Access Compliance Report

Public Rights-of-Way

(Curb Ramps)

Intersection ID: 10077	Main Street: E_35TH_ST	Cross Street: N_DAVIDSON_ST	Location: SE
ADA ID: BC3669640242	Ramp Type: PerpDiag	Initial Pass/Fail: Fail	Overall Compliance: No
Severity Score: 13.75			
Codes/Mitigation Info/Possible Solution		Field Measurements/Component Compliance

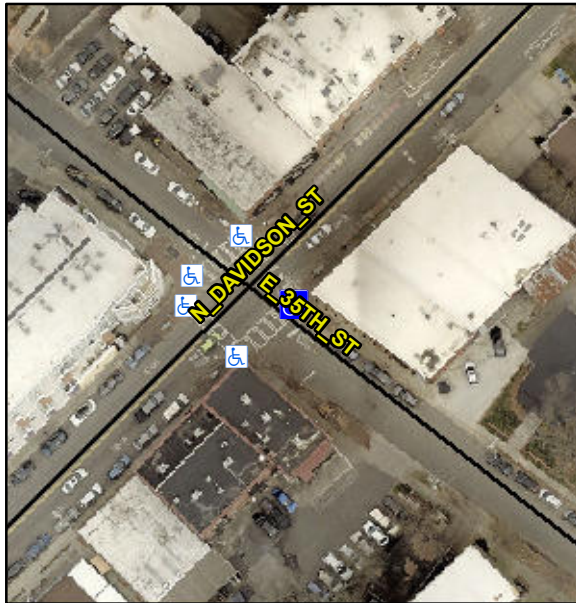
R304.2.2, R304.5.3

Compliance	Description	Data	Compliance	Description	Data
N/A	Ramp Length (in)	78.0	No	Ramp Slope (%)	9.5
Yes	Ramp Width (in)	48.0	No	Ramp XSlope (%)	2.6
N/A	Flare Type LT	N/A	N/A	Flare Type RT	N/A
N/A	Flare Slope LT (%)	N/A	N/A	Flare Slope RT (%)	N/A
N/A	Flare Traversable LT?	N/A	N/A	Flare Traversable RT?	N/A
N/A	Landing Length (in)	N/A	N/A	DWS Provided?	N/A
N/A	Landing Width (in)	N/A	N/A	DWS Contrast?	N/A
N/A	Landing Slope (%)	N/A	N/A	DWS Length (in)	N/A
N/A	Landing X Slope (%)	N/A	N/A	DWS Full Width?	N/A
N/A	Landing Curb? (Y/N)	N/A	N/A	DWS Offset (in)	N/A
N/A	Shared Landing?	N/A			
N/A	Gutter Ponding?	N/A	N/A	Gutter Slope (%)	N/A
N/A	Gutter Lip Ht (in)	1.0	N/A	Gutter X Slope (%)	N/A
N/A	Painted X Walk1?	Yes	N/A	Painted X Walk2?	Yes
	X Walk 1 Direction	To NW		X Walk 2 Direction	To SW
N/A	X Walk 1 Width (in)	74.0	N/A	X Walk 2 Width (in)	111.0
	X Walk 1 Slope (%)	2.5		X Walk 2 Slope (%)	0.5
	X Walk 1 X Slope (%)	1.9		X Walk 2 X Slope (%)	2.4

N/A	Ramp inside XWalk1?	Yes	N/A	Ramp inside XWalk2?	Yes
	Road Slope (%)	2.5	N/A	Clear Space?	N/A
	Road X Slope (%)	1.1	N/A	Clear Space to XWalk (in)	N/A
N/A	Any Obstructions?	N/A	N/A	Storm Grate/Utility Hazard?	N/A
	Obstruction Type			Storm Grate/Utility Type	
		N/A			N/A
		Yes		Surface Condition? (G/P)	Good

Remove & Replace Curb Ramp With Two New Directional Ramps or Equivalent.
